Fairhope Planning Commission Agenda

January 5, 2026 – 5:00 PM

SR 25.08 - Fairhope Boarding House

Request of the Applicant, S.E. Civil, LLC, on behalf of the Owner, FST SILDI, LLC, for Site Plan Approval of Fairhope Boarding House. The property is approximately 0.20 acres and is zoned B-2 – General Business District. The property is located at 301 Fairhope Avenue.

SITE PLAN

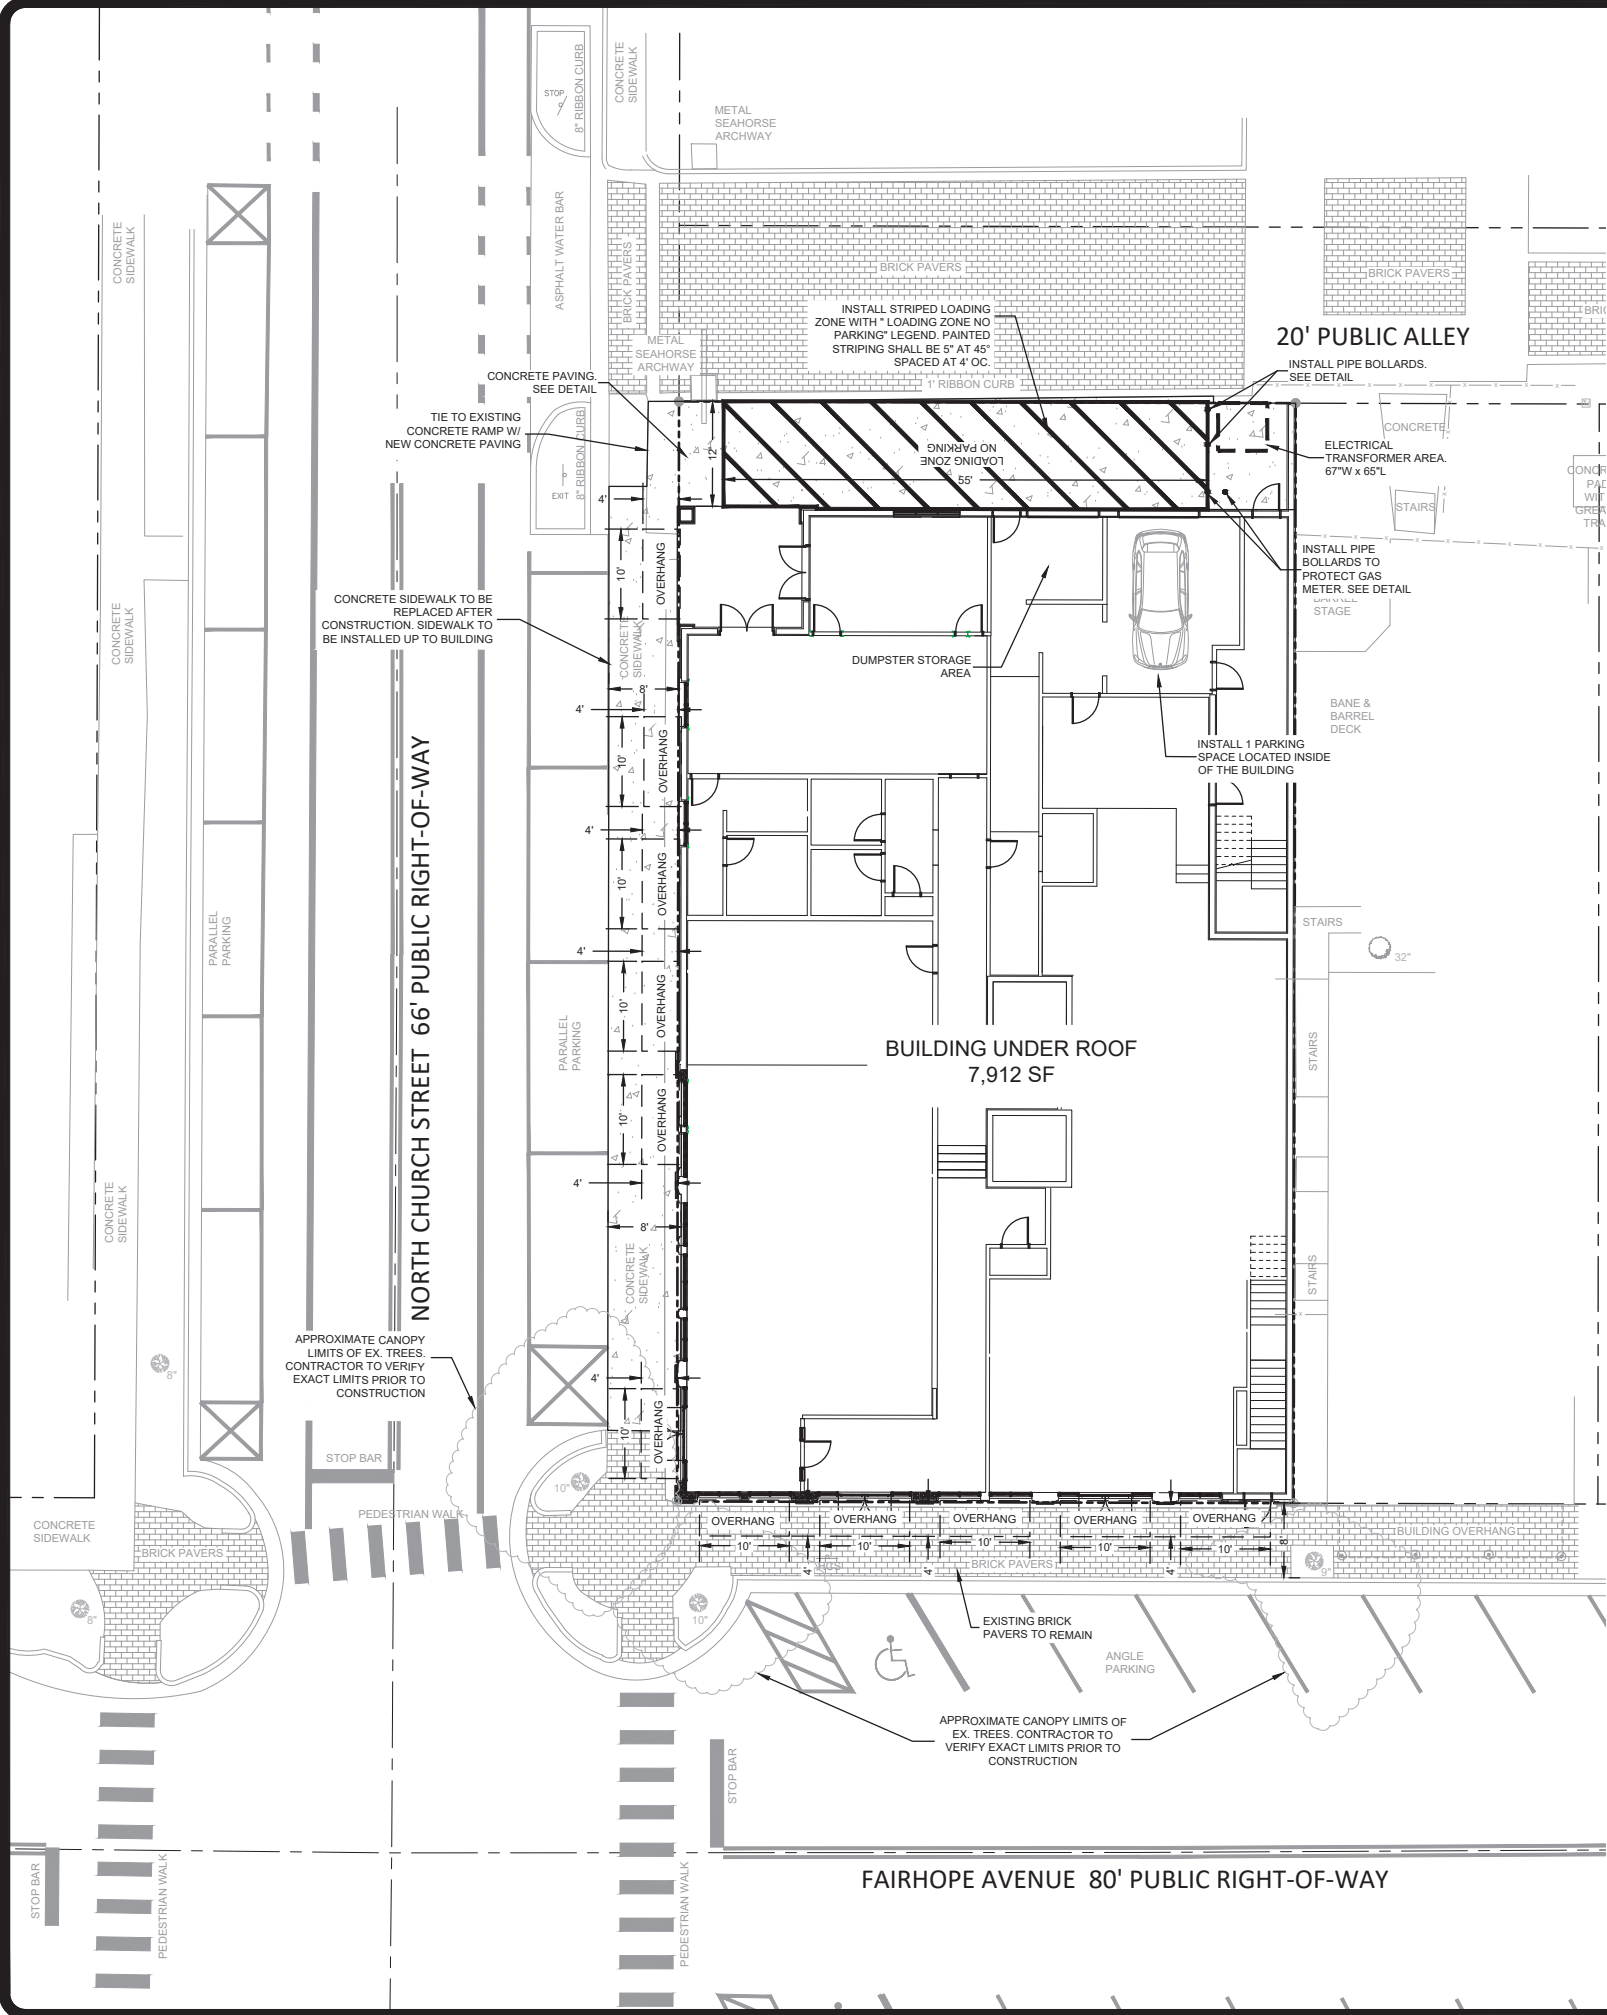
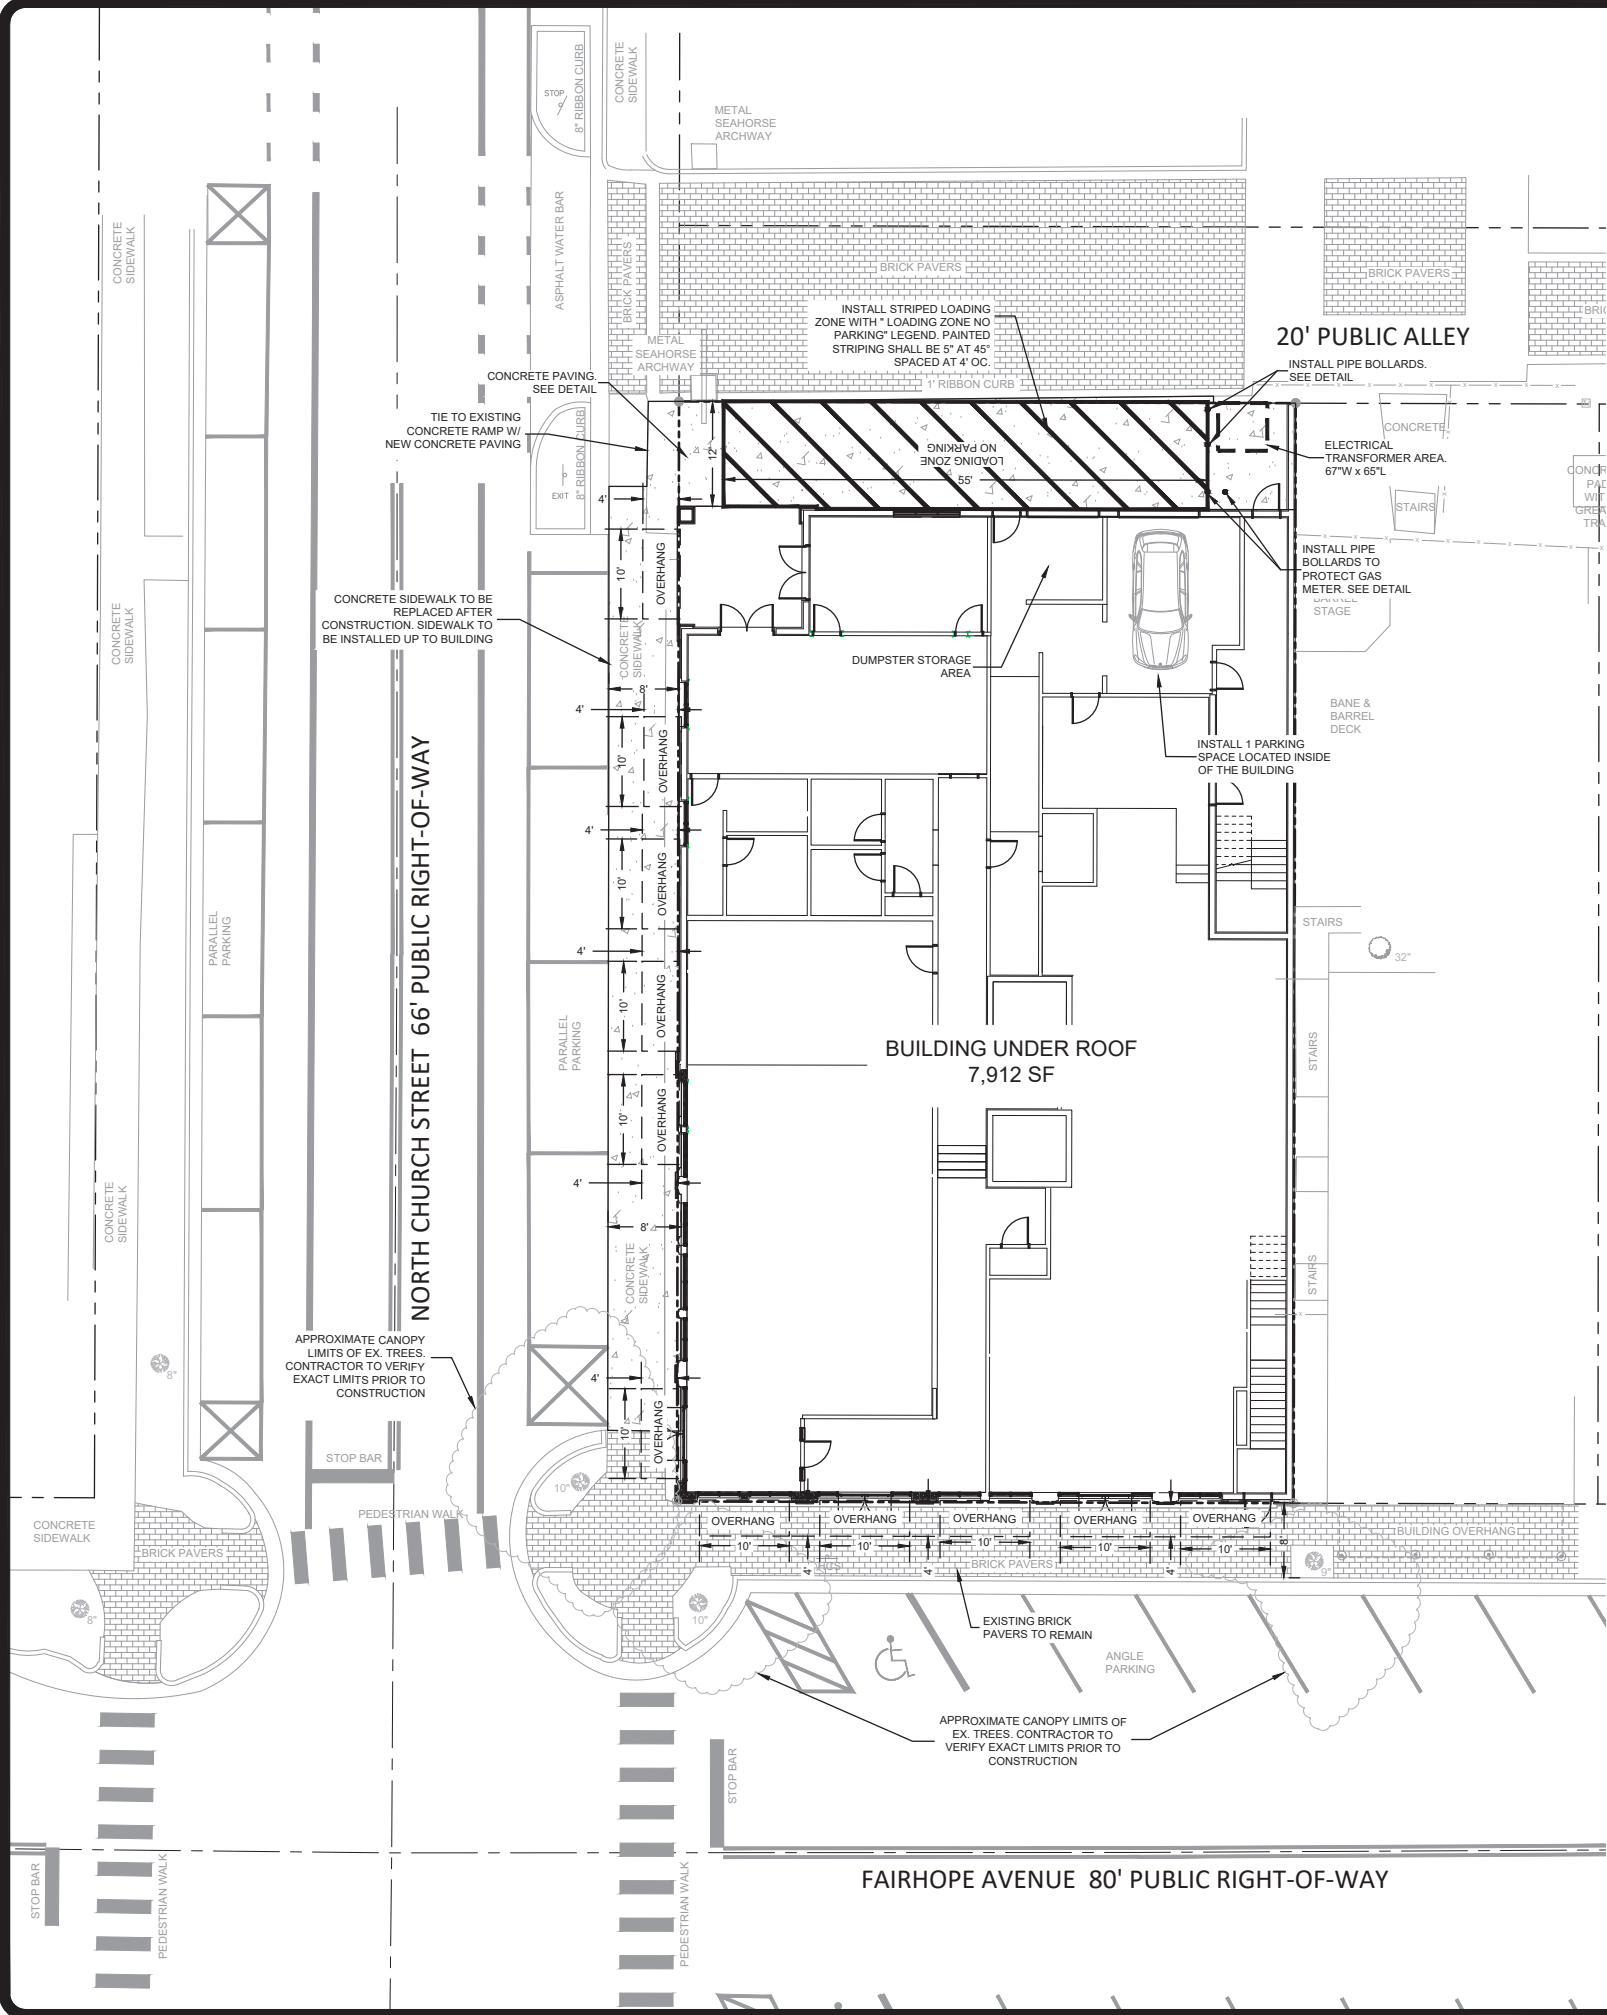
The proposed site plan is attached to the end of this report as an exhibit. A Multiple Occupancy Project application (SD 25.16) has also been submitted and is under review. The proposed building will contain a 26-room boarding house with a rooftop terrace that will have a live-in onsite manager/owner, a Med-Spa, and restaurant. It's important to note that the Med-Spa is a Use on Appeal which requires approval by the Board of Adjustments.

The Site Plan illustrates a dumpster under the building with a roll up door accessed from the Art's Alley through the loading zone and will be private.

Staff has concerns with the different services required to provide for the proposed uses and the space and the intensity of the cumulative effect. Housekeeping closets have been added to the 2nd and 3rd floor as well as bathrooms converted to storage space on the roof top terrace.

Staff recommends **Approval** of SR 25.08 – Fairhope Boarding House Site Plan with the following conditions:

1. Approval of the associated Multiple Occupancy Project case SD 25.16 by the Fairhope City Council;
and
2. Revision of the utility plans to reflect the minimum 78" x 75" transformer pad.
